# Memorandum

To	Douglas Shire Council and Department of State Development, Manufacturing, Infrastructure and Planning		
From	Sarah Wilson - GHD	Tel	+61 7 5413 8133
Subject	Response to information request from Douglas Shire Council (DSC) and Department of State Development, Manufacturing, Infrastructure and Planning (DSDMIP) Wangetti Trail SP1 - Combined Development Application Response to request for information 1909-13127 SRA	Job no.	4132458

We refer to the Development Application Council Ref: CA3212/2019 and SARA Ref:1909-13127 SRA associated with the proposed Wangetti Trail SP1 and provide responses to the information request issued by Douglas Shire Council (DSC) and Department of State Development, Manufacturing, Infrastructure and Planning (DSDMIP) in accordance with Part 3, Section 13.1 of the Development Assessment Rules.

G:\4132458\GIS\Maps\MXD\4132458\_035\_WT\_SP1\_OW\_MarinePlantDisturbance\_MultiPg\_Rev2.mxd  
Print date: 31 Oct 2019 - 12:17

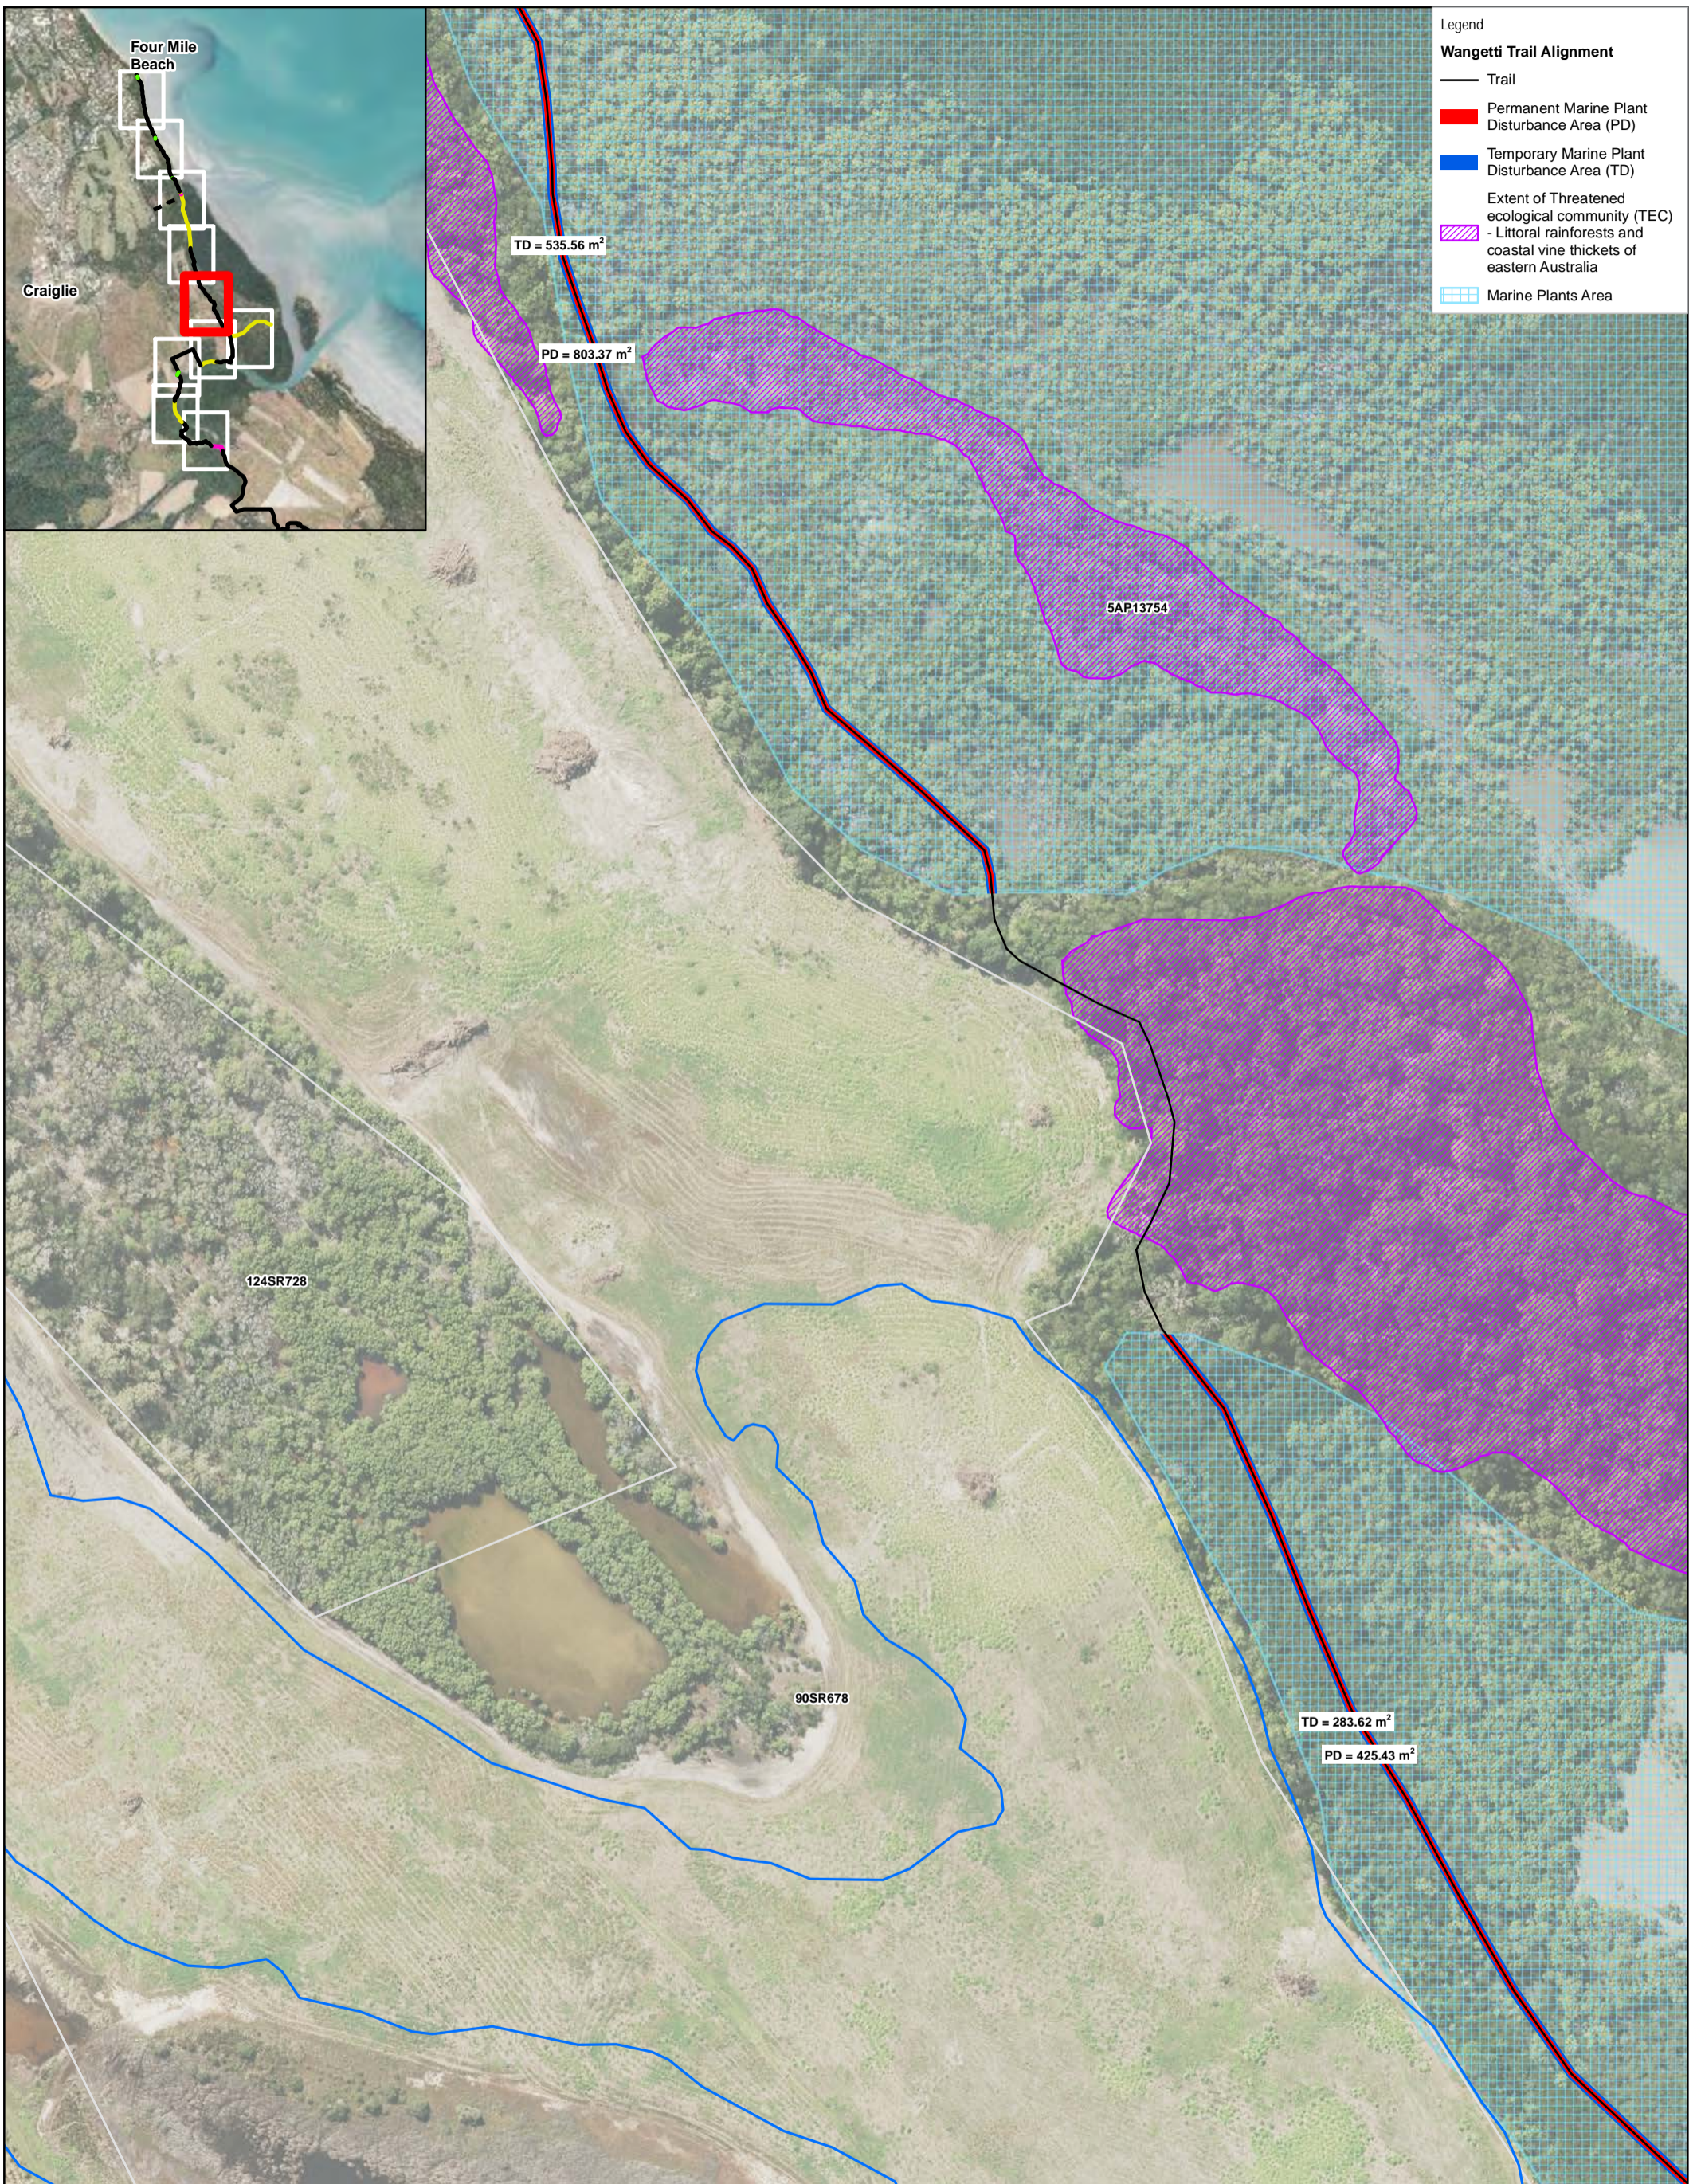
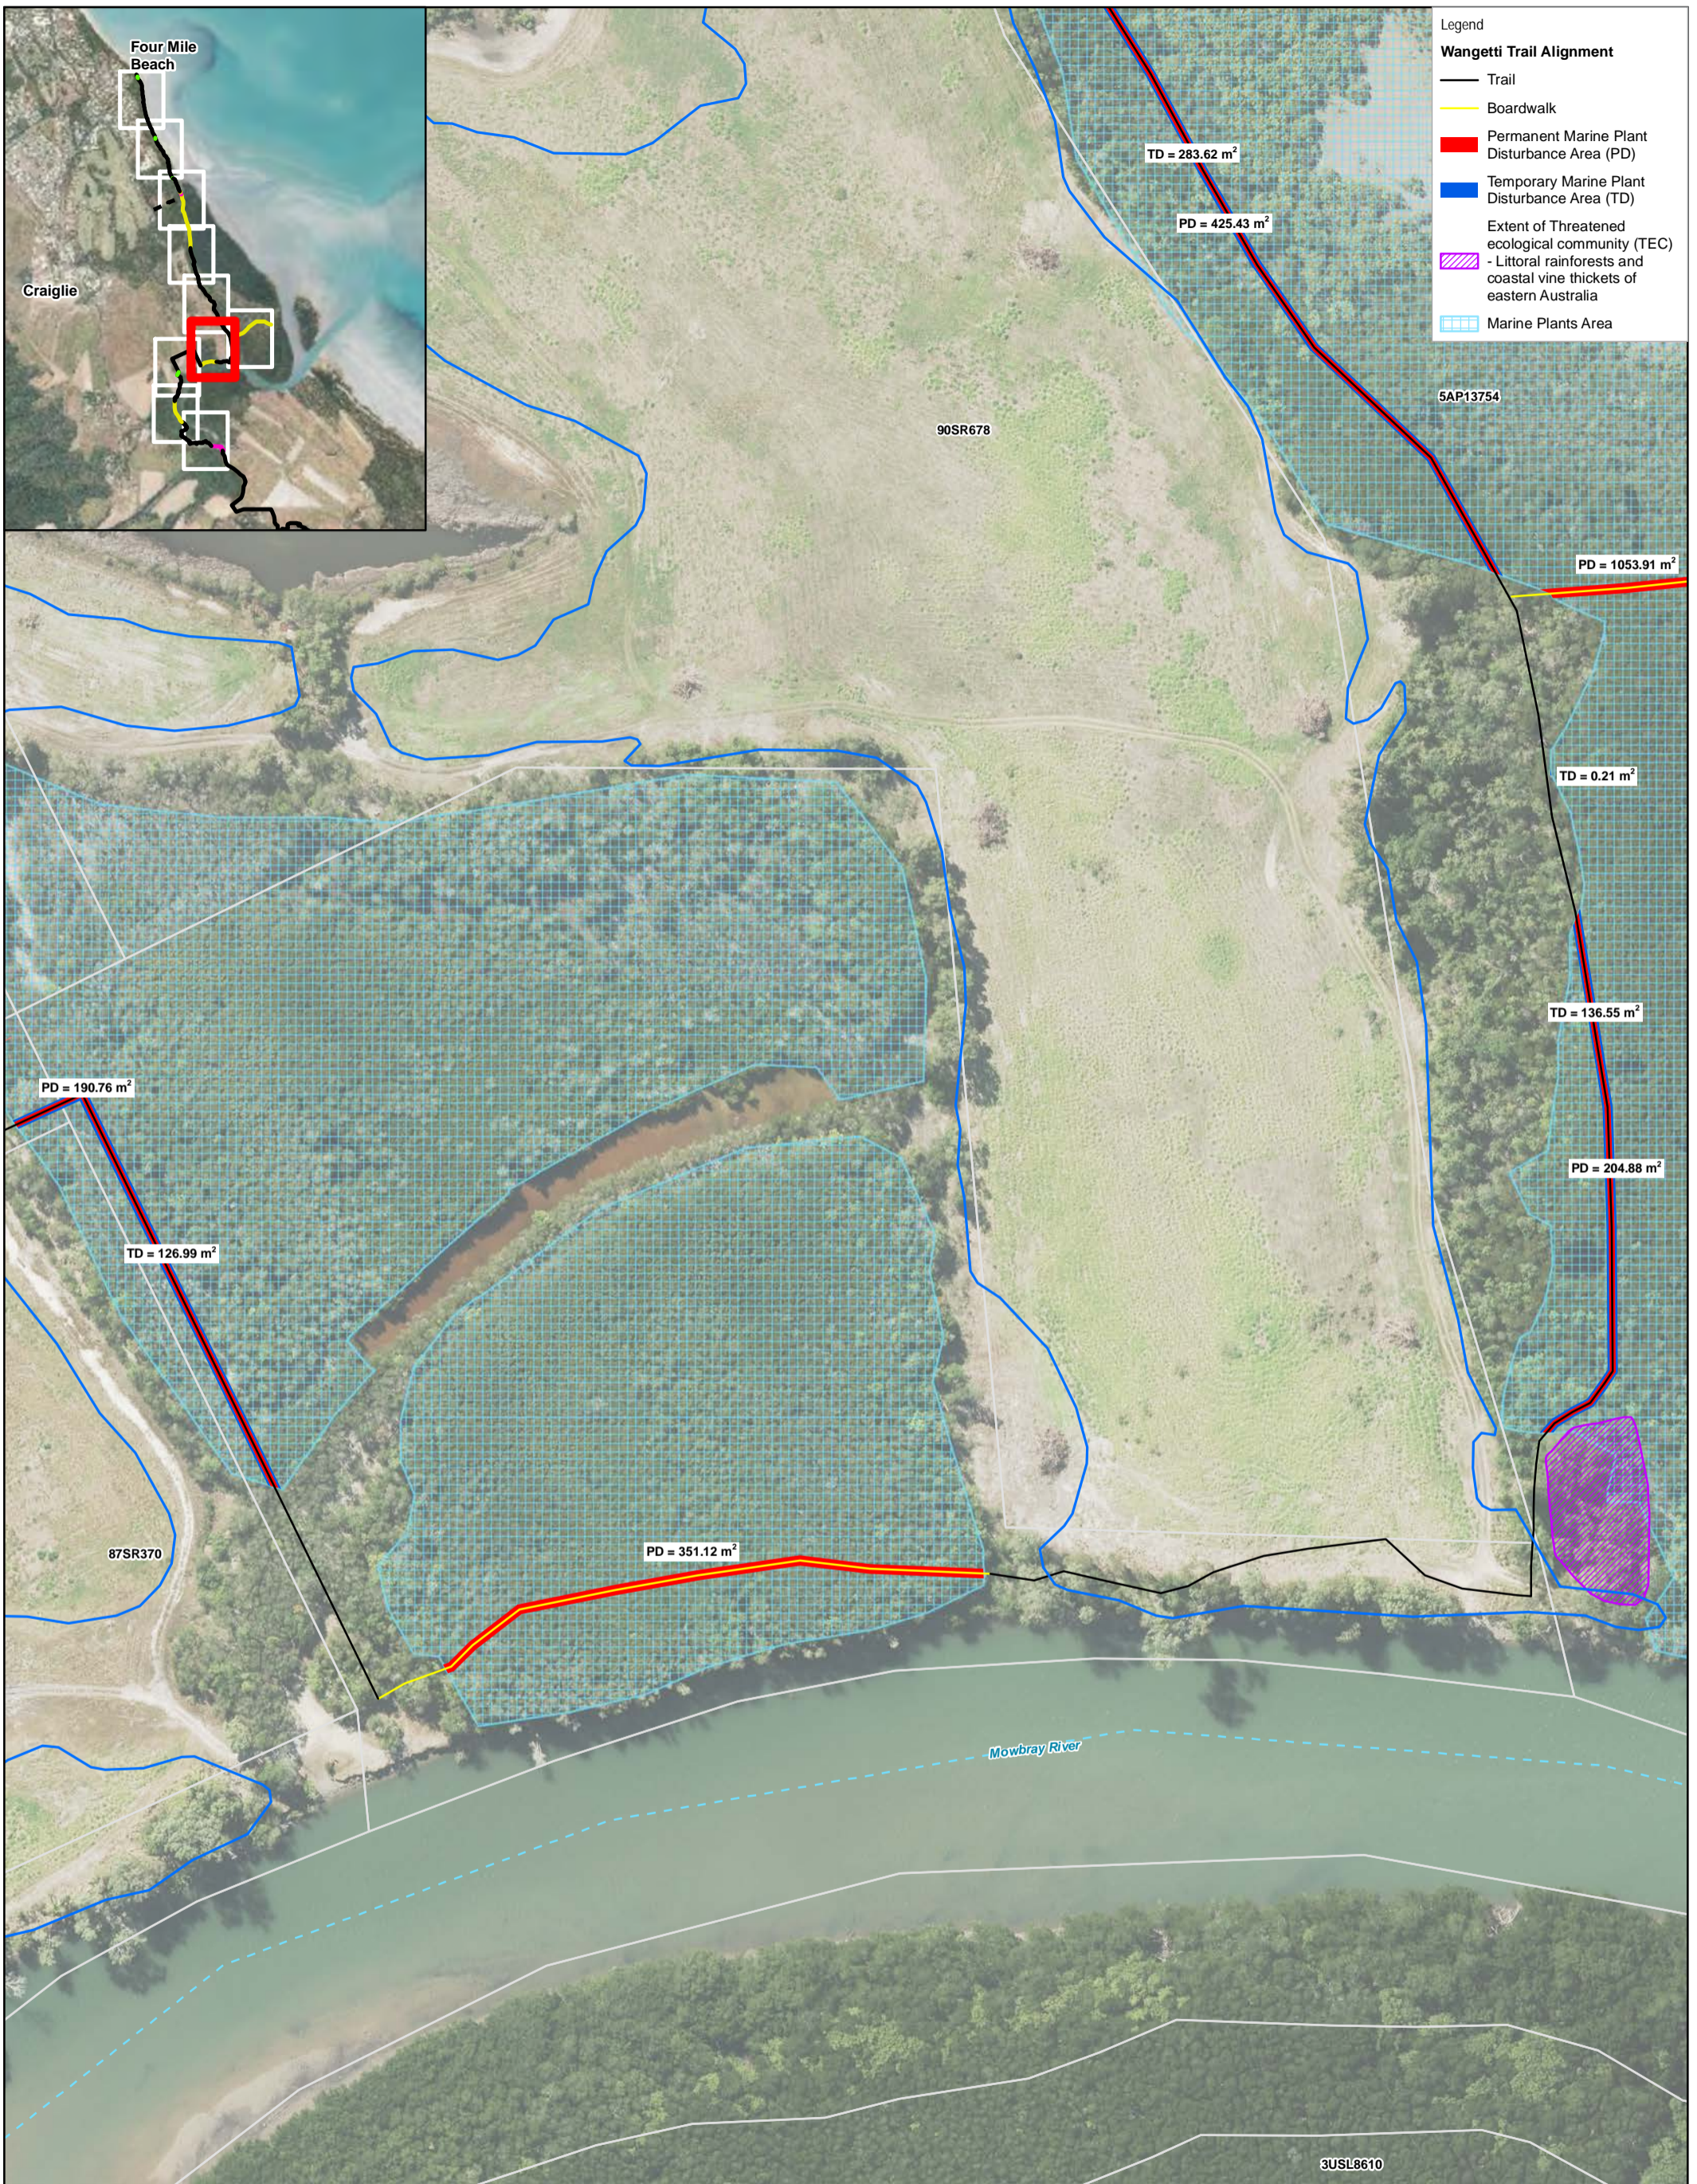
- b) *Provide maps identifying all locations where the trail will be constructed within TEC communities.*
- c) *Identify all locations where crushed rock will be used to construct the track and any creek crossings where rocks are proposed.*
- d) *Provide detailed information of the compacted trail construction and the impacts it will have to the existing profiles of tidal land.*
- e) *Demonstrate the compacted trail will not impact tidal flow and fragment tidal lands.*
- f) *Provide information of the existing tidal land levels (i.e. contour lines).*
- g) *Discuss the natural tidal inundation levels and connectivity of all adjacent habitat under elevated flow events. This discussion should include any impacts the proposed works will have on the existing connectivity.*
- h) *Discuss all potential impacts the proposed works will have on marine plants and fisheries resources.*

**Item 3 (c) Provide the individual marine plant disturbance area in meters squared (m<sup>2</sup>) for each works component.**

Figure 2 shows the location of the proposed trail and boardwalk and the location of threatened ecological community (TEC) - Littoral rainforests and coastal vine thickets of eastern Australia. The SP1 alignment has been designed to predominantly avoid areas of TEC, however the trail intersects with a small area of TEC, located approximately 600 m north of the Mowbray River. The TEC was not previously mapped in government databases and was recorded during the site investigation of the area. Based on the composition of the vegetation within the TEC area, it was determined not to contain high fisheries significant plants.

A breakdown of the marine plant disturbance including temporary and permanent disturbance has been provided in Table 3-2 of the Environment Assessment Stage 2 Wangetti Trail Planning Report for Operational Work - SP1 Marine Plant Disturbance Report and is outlined in Table 5 below and shown in Figure 2.
